Response to FCC's International Bureau/Satellite Divisions Concerns

Subject: Request for Info - File # 0305-EX-CN-2017

Reference number : 38209

Dated: August 11, 2017

Earth Station Antenna Pattern for both transmit and receive.

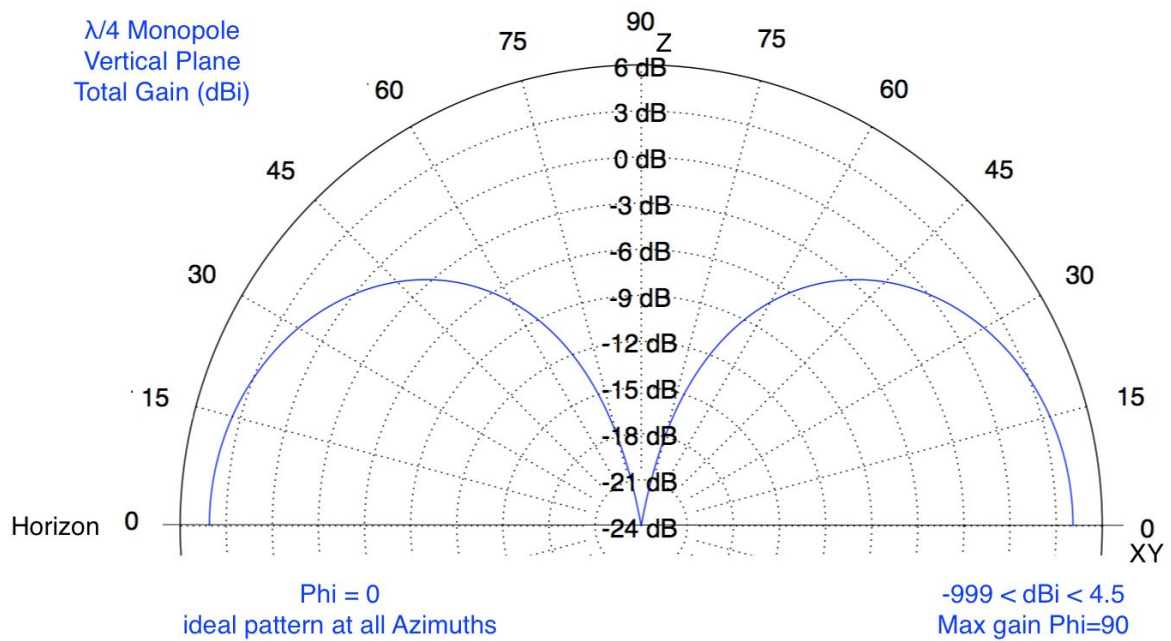
Please redo the antenna patterns provided without the satellite names, antenna height, power levels, orbital parameters; only include technical information related to the antenna characteristics.

The antenna patterns are updated as shown below. They are also updated in the SpaceCap API database file.
